# UNITED STATES PATENT AND TRADEMARK OFFICE

APPLICATION NO.	FILING DATE	FIRST NAMED INVENTOR	ATTORNEY DOCKET NO.	CONFIRMATION NO.
10/527,800	03/15/2005	Hikofumi Yamamoto	052277	9561

**Office Action Summary**

## **DETAILED ACTION**

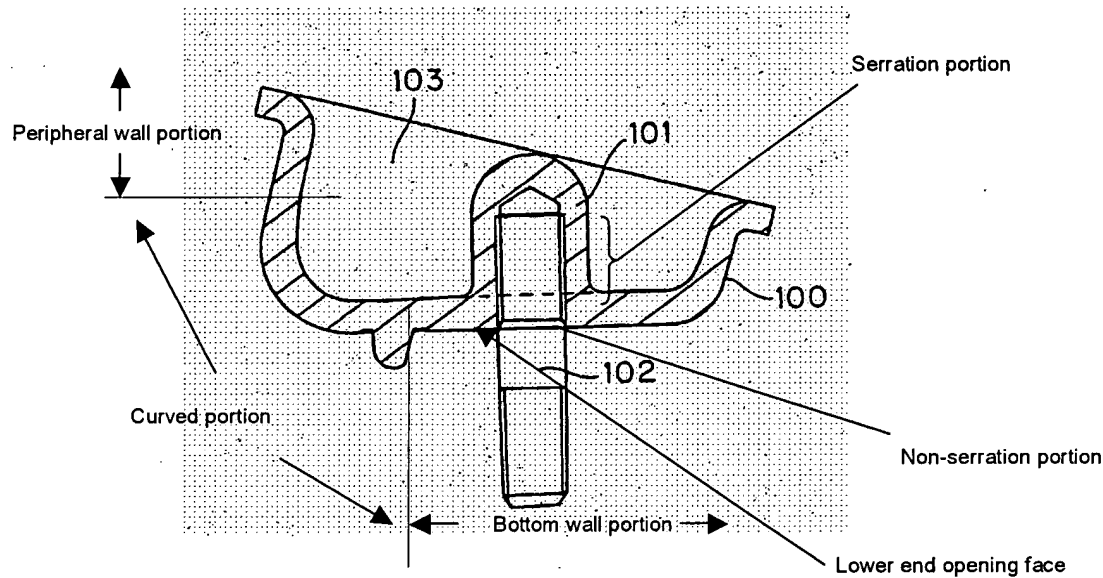
Re: claims 3, 5, and 10. Prior art figure 6 shows a hydraulic vibration proof device comprising: a cup-shaped second attachment 100 forming an air chamber 103 which is characterized in that the second attachment fitting is fabricated from aluminum as disclosed in paragraph [0007] and includes a peripheral wall portion and a curved portion interposed between the bottom wall portion and the peripheral wall portion and

curved in an arc form in axial cross-section, the bottom wall portion is defined with a hole and having a bolt.

Re: claim 6. Prior art figure 6, as modified teaches in Prior art figure 6 the limitation wherein a length of the serration portion is set to be shorter than a depth of the hole, thus providing the non-serration bonding portion between the serration portion and a lower end opening face of the hole.

face of the hole providing the non-serration bonding portion shown at the section within the hole in the bottom wall portion above section 102 of the bolt, but lacks the limitation of the lower end opening face being chamfered.

Applicant next states that it is "unclear whether the Office action argues that JP'145 discloses the recited changes in thickness." Examiner notes that JP'145 is not relied upon for teaching the recited changes in thickness. Examiner maintains that the thickness changing limitations are satisfied by the Prior art figure 6 as illustrated in the annotated copy of Prior art figure 6 provided on pg. 3 of the instant Office action.
